**TO**: Design Review Commission

**SUBJECT**: 18-SC-32 – 570 Torwood Lane

Approve design review application 18-SC-32 subject to the listed findings and conditions

This is a design review application for a two-story addition to an existing one-story house. The proposed project includes the demolition of a 535 square-foot garage and construction of a new 509 square-foot garage and a second story addition of 597 square feet over it. The following table summarizes the project's technical details:

Location of protected trees and new construction

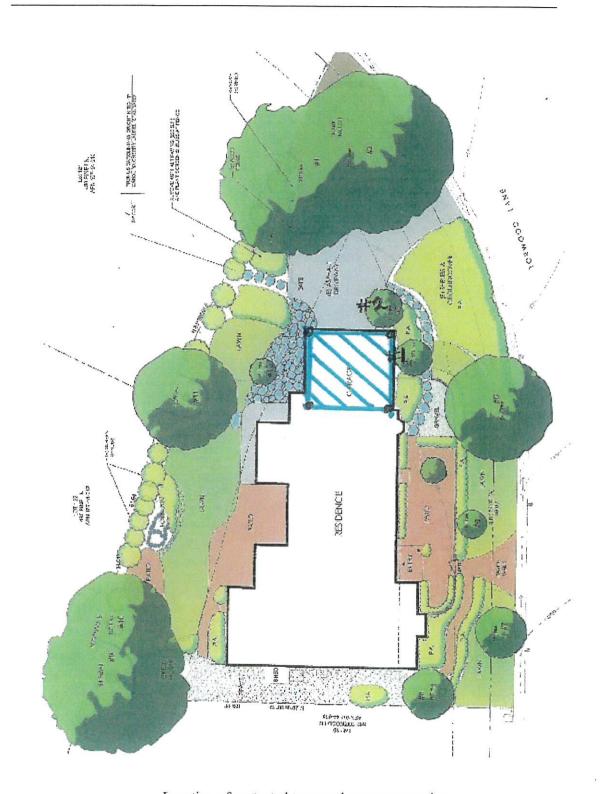
- 2. The garage will be moved about 2 ½ feet foot further away from Tree # 2 to 5 ½ feet from the tree and 1 ½ feet closer to Tree # 1 to 5 ½ feet from the tree. A pier will be dug at the corner of the garage between the two protected trees. The top 18 inches of this pier should be hand dug to avoid any conflict with the roots.
